# Access Compliance Report

## Public Rights-of-Way

### (Curb Ramps)

Intersection ID: 5468	Main Street: N_TRYON_ST	Cross Street: J_W_CLAY_BV	Location: E
ADA ID: 6A19509A4924	Ramp Type: Perp	Initial Pass/Fail: Fail	Overall Compliance: No
Codes/Mitigation Info/Possible Solution		Field Measurements/Component Compliance	
Severity Score: 8.75

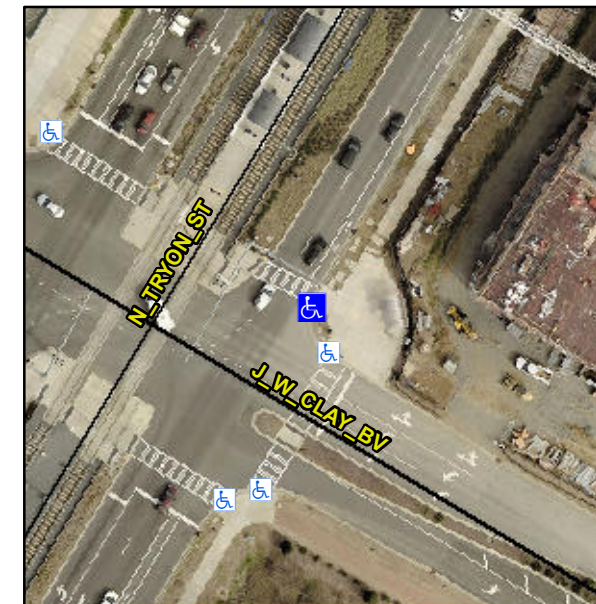
Compliance	Description	Data	Compliance	Description	Data
N/A	Ramp Length (in)	106.0	Yes	Ramp Slope (%)	7.6
No	Ramp Width (in)	46.0	Yes	Ramp XSlope (%)	1.0
N/A	Flare Type LT	N/A	N/A	Flare Type RT	N/A
N/A	Flare Slope LT (%)	N/A	N/A	Flare Slope RT (%)	N/A
N/A	Flare Traversable LT?	N/A	N/A	Flare Traversable RT?	N/A
N/A	Landing Length (in)	N/A	N/A	DWS Provided?	N/A
N/A	Landing Width (in)	N/A	N/A	DWS Contrast?	N/A
N/A	Landing Slope (%)	N/A	N/A	DWS Length (in)	N/A
N/A	Landing X Slope (%)	N/A	N/A	DWS Full Width?	N/A
N/A	Landing Curb? (Y/N)	N/A	N/A	DWS Offset (in)	N/A
N/A	Shared Landing?	N/A			
N/A	Gutter Ponding?	N/A	N/A	Gutter Slope (%)	N/A
N/A	Gutter Lip Ht (in)	N/A	N/A	Gutter X Slope (%)	N/A
N/A	Painted X Walk1?	No	N/A	Painted X Walk2?	N/A
	X Walk 1 Direction	To NW		X Walk 2 Direction	N/A
N/A	X Walk 1 Width (in)	N/A	N/A	X Walk 2 Width (in)	N/A
	X Walk 1 Slope (%)	1.2		X Walk 2 Slope (%)	N/A
	X Walk 1 X Slope (%)	0.8		X Walk 2 X Slope (%)	N/A

**Remove & Replace Entire Ramp.**

**R304.5.1**
